Re: Highland Livestock and Land Co., Ltd. Water Right Permit Nos. 63-33960, 63-34429, and 63-34876 Beneficial Use Field Examinations Response to Additional Information Request

RE: Water Right Permits No. 63-33690, 63-34429, and 63-34876

SUBJECT: Licensing Review of Water Right 63-33960 and 63-3487

RE: Field exam report for water right permits 63-33960, 63-34429, and 63-34876.

Permit 63-33960:

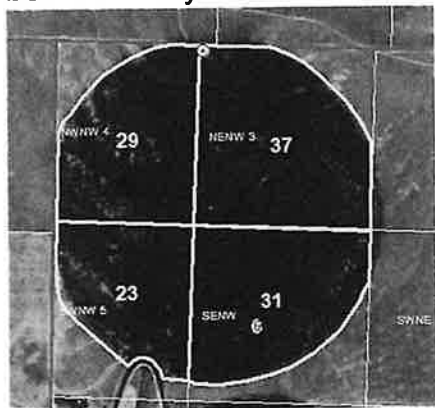
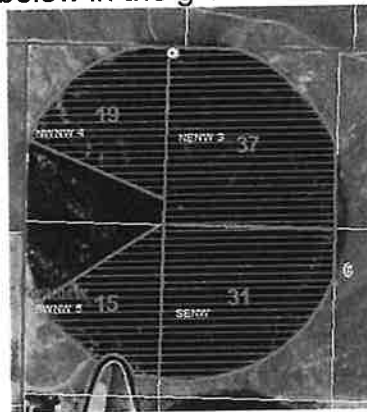
The field examiner requested that this permit be licensed as having a permissible place of use with the full acres and diversion rate authorized by the permit. It appears as though the entire pivot has been irrigated, since the water was first put to beneficial use. The system does not appear to have been operated by using each water right individually using the full diversion rate authorized by each right. Based on the permit development, we will not be able to issue a license on this permit for more than an average diversion rate per acre for the 102 acres authorized by this right. This right will be recommended at a diversion rate of 1.64 cubic feet per second and the 459 acre-feet of annual volume based on the diversion rate and volume actually applied to the 102 acres irrigated under this right.

An amendment can be filed to allow this right to irrigate any 102 acres in a single season within the 120 acre pivot described in his field report. This will allow you to move the acres around each irrigation season to cover the most important 102 acres if water right 63-34876 is curtailed to ensure you are irrigating the 102 acres best served by the system. If you wish to have this flexibility, you will need to sign the amendment and return it with the \$100.00 fee.

With the amendment, you will be able to irrigate 102 acres within the 120 acre area shown below in the yellow border.

If you decide to not sign the amendment and not pay the \$100.00 amendment fee, you will be limited to the 102 acres shown below in the green border.

Permit 63-34876:

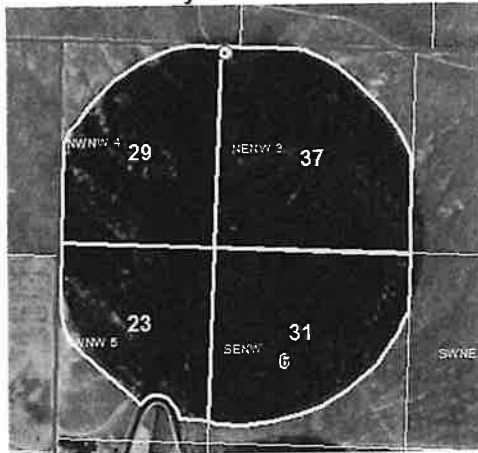
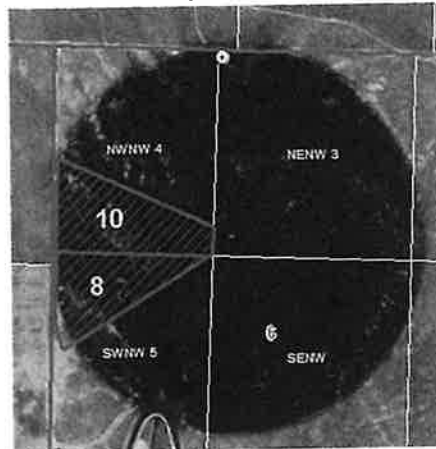
The field examiner requested that this permit be licensed as having a permissible place of use with the full acres and diversion rate authorized by the permit. As stated above, we will not be able to give the full diversion rate and acres authorized above, because the full pivot has never been operated in a manner to separate out the individual rights. The license for this permit will authorize 0.29 cubic feet per second, 81 acre-feet of annual volume, and 18 acres developed in this system in addition to the diversion rate, volume, and acres authorized by water right 63-33960.

An amendment will allow you to move the 18 acres associated with this right to different areas within the pivot. You will be able to adjust the location that will ensure the best use of the land if a call limits this right or water right 63-33960. In order to have this flexibility, you will need to sign the enclosed amendment for water right 63-34876 and return it with a \$100.00 fee.

With the amendment, you will be able to irrigate 18 acres within the 120 acre area shown below in the yellow border.

If you decide to not sign the amendment and not pay the \$100.00 amendment fee, you will be limited to the 18 acres shown below in the purple border.

Permit 63-34429:

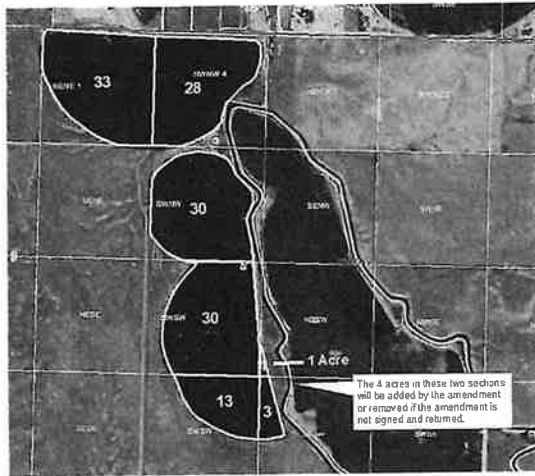
The field examiner requested that the acres originally authorized by this permit be adjusted to cover 4 acres in the NE $\frac{1}{4}$ SW $\frac{1}{4}$ and the SE $\frac{1}{4}$ SW $\frac{1}{4}$ of Section 2 in Township 5 North, Range 4 West. The 4 acres were not included on your original permit, so the certified water right examiner requested that the permit be amended to include these lands. The certified water right examiner also provided documentation that you have entered into an agreement to irrigate those 4 acres. Please see the map below for identification of the 4 acres in question:

The 4 acres shown on the southeastern side of the southernmost pivot are the 4 acres that need to be added to the permit by an amendment if they are going to continue to be irrigated. If you choose not to amend this water right, we will remove these acres from the proposed license.

If you choose not to sign the amendment for permit 63-34429, we will remove the 4 acres from the licensing of this permit, which will reduce the license to 2.68 cubic feet per second, 603 acre-feet for the irrigation of the remaining 134 acres.

Dave Little
12NC 5 stage,
925 GPM @ 400' TDH

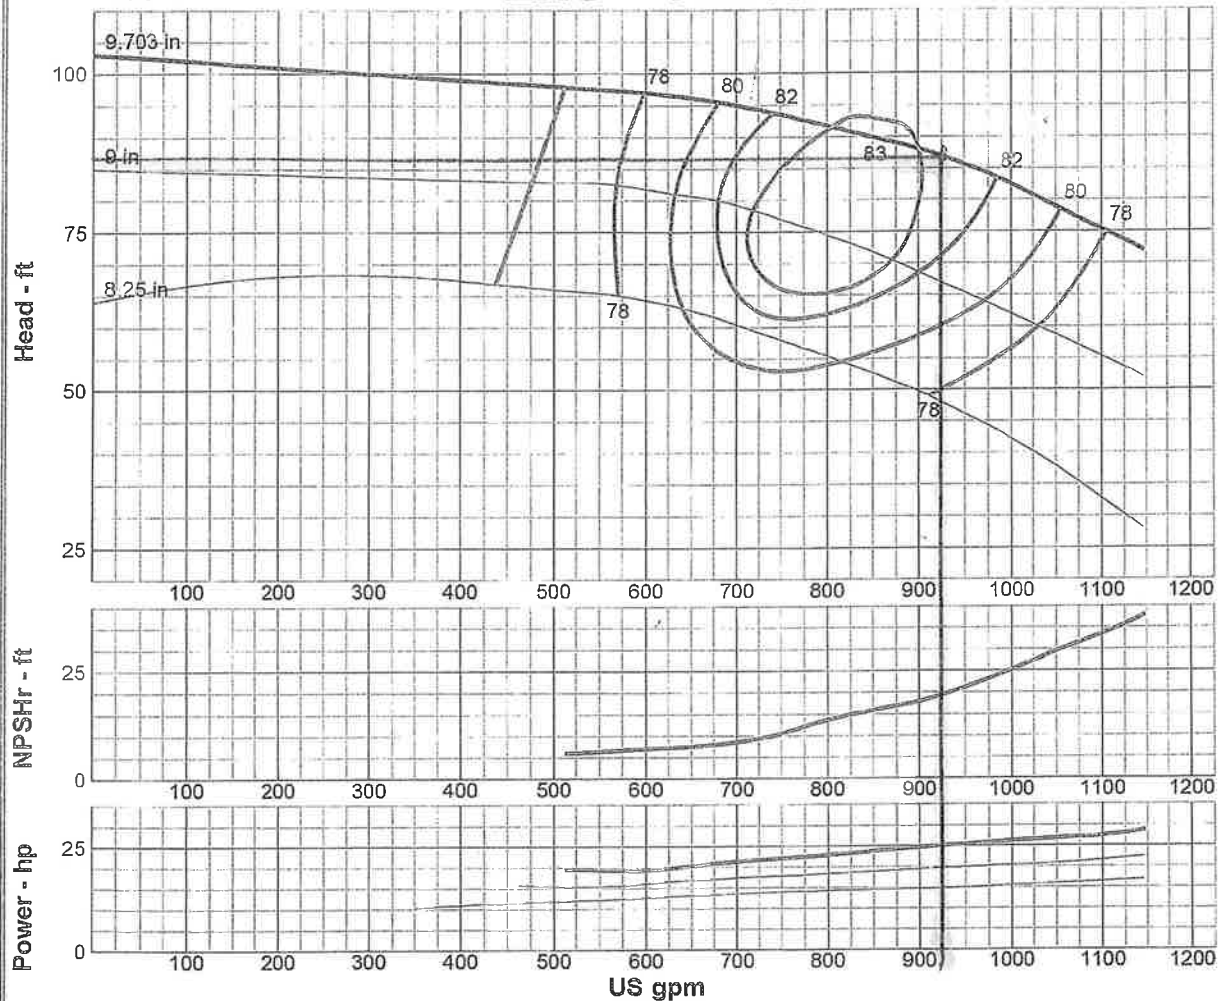
In my September 21, 2020, rejection letter, I suggested that the flow rate measured by Mr. Shaw seemed to be a bit low based on the information that I had available to me at that time. Mr. Shaw provided pump curves for the well pump with his April 29, 2021, letter. In reviewing these pump curves, I am still concerned that the flow rate measured by Mr. Shaw could be less than the system could provide. Without any field notes or additional information to dispute Mr. Shaw's original measurement, I am limited to the flow rate measured by Mr. Shaw.

The 1.93 cfs measured at 10:10 am on 8-21-2020 matches closely to the 925 gpm design for this well and pump installation, copy enclosed. The pump and well have been in use since 2016 so a 6½% reduction from the design capacity of the well and pump should not be unexpected.
